Paper 4

Landscape Officer Response

Tibberchindy Wind Farm: Landscape Response

Figure 2

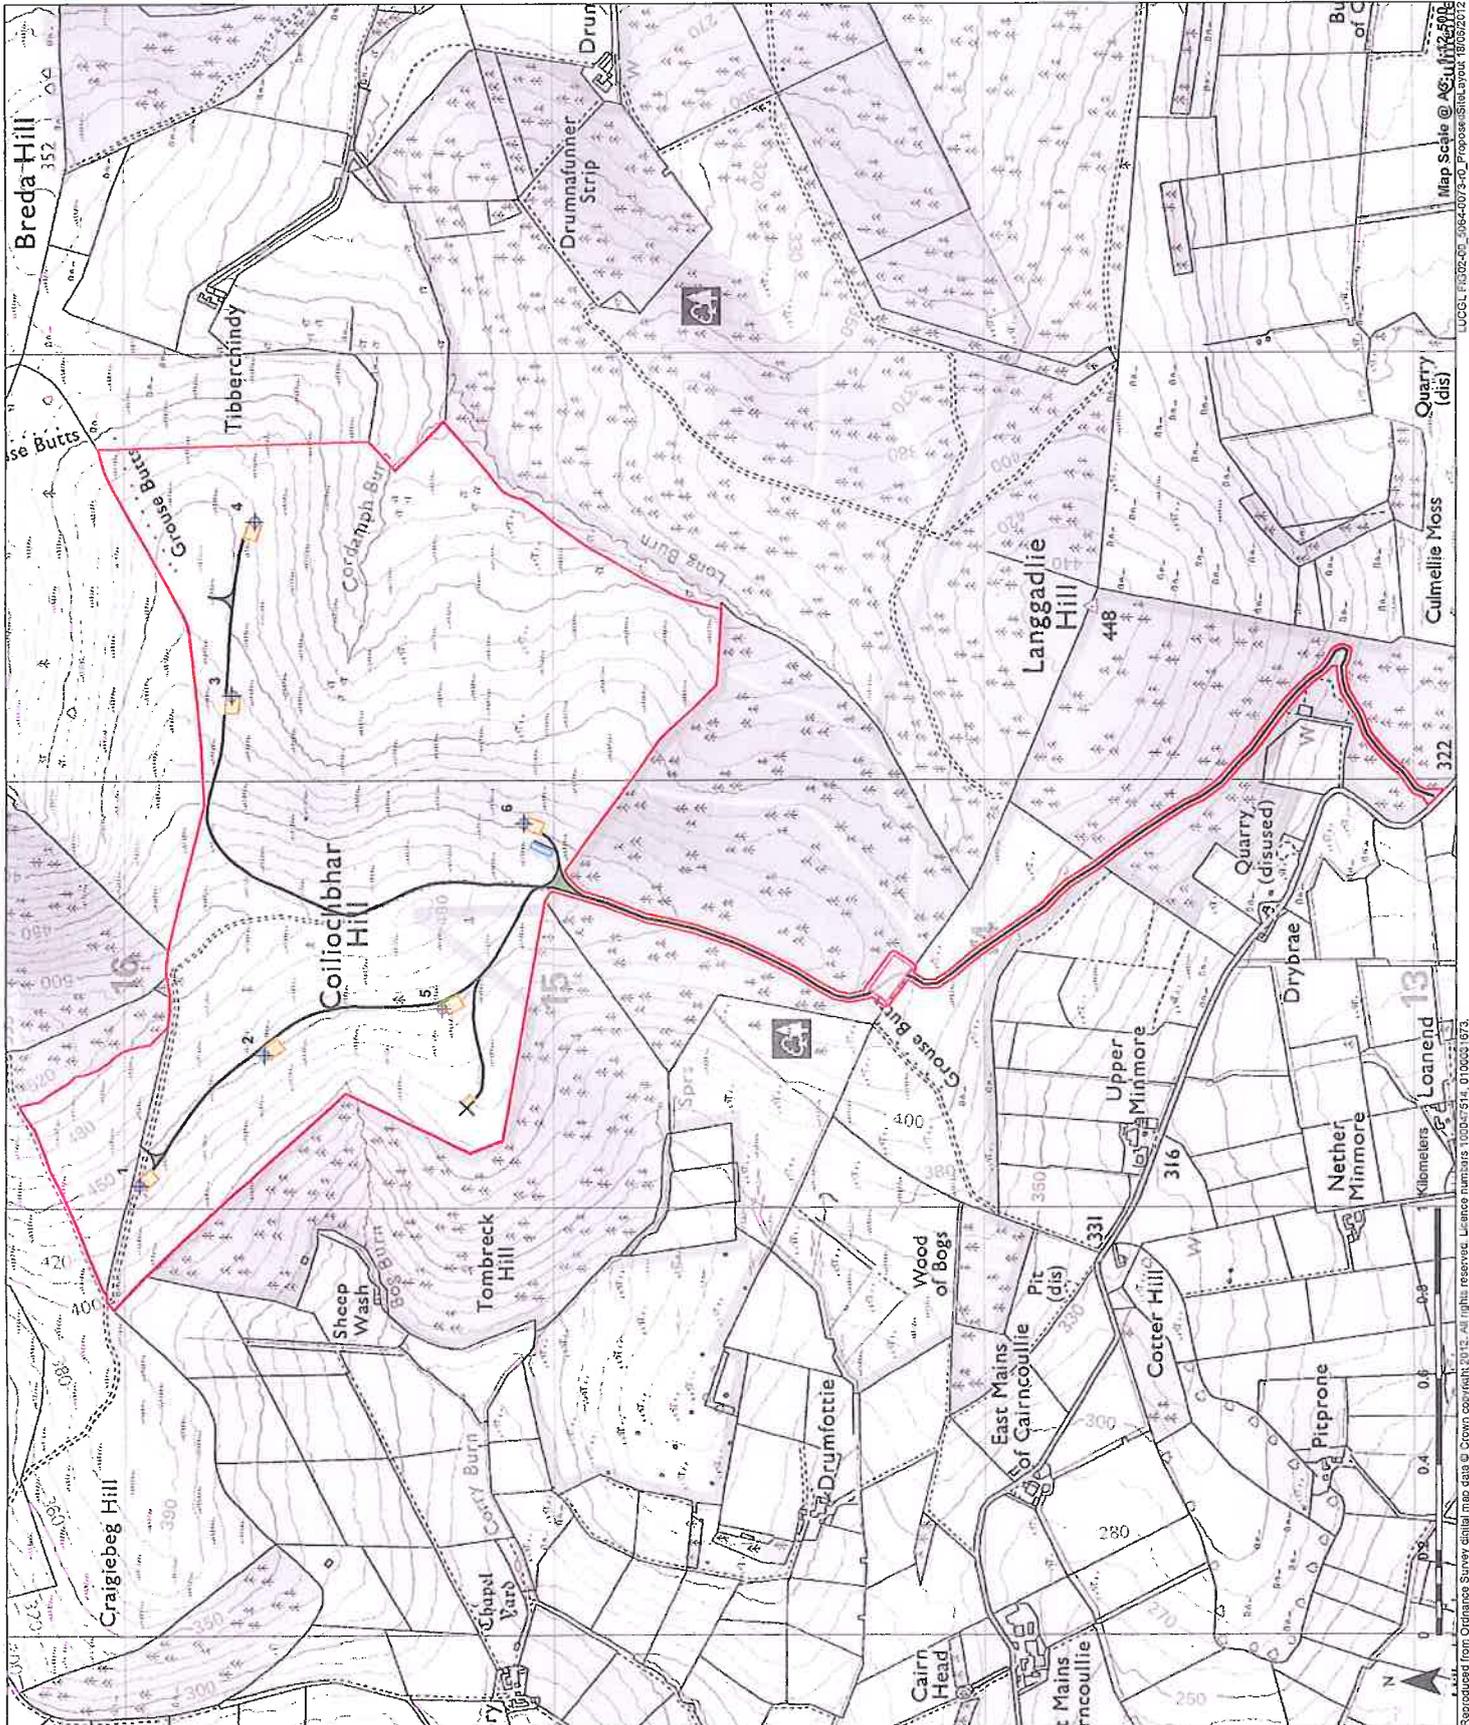
Within views from the Park (view pts 3, 7, 9 and 10) the turbines range along the hill slopes of Coiliochbar, generally it is the 4 most westerly turbines that figure in these views. These turbines appear in a simple elongated array, widely but evenly spaced along the hillside. Though the composition as viewed from the Park is generally simple, the relationship between individual turbine positions and landform appears variable with the line of 4 turbines not quite following the hill slope.

Advice: A closer spacing of the 4 western turbines in a more compact arrangement might produce a better fit with landform.
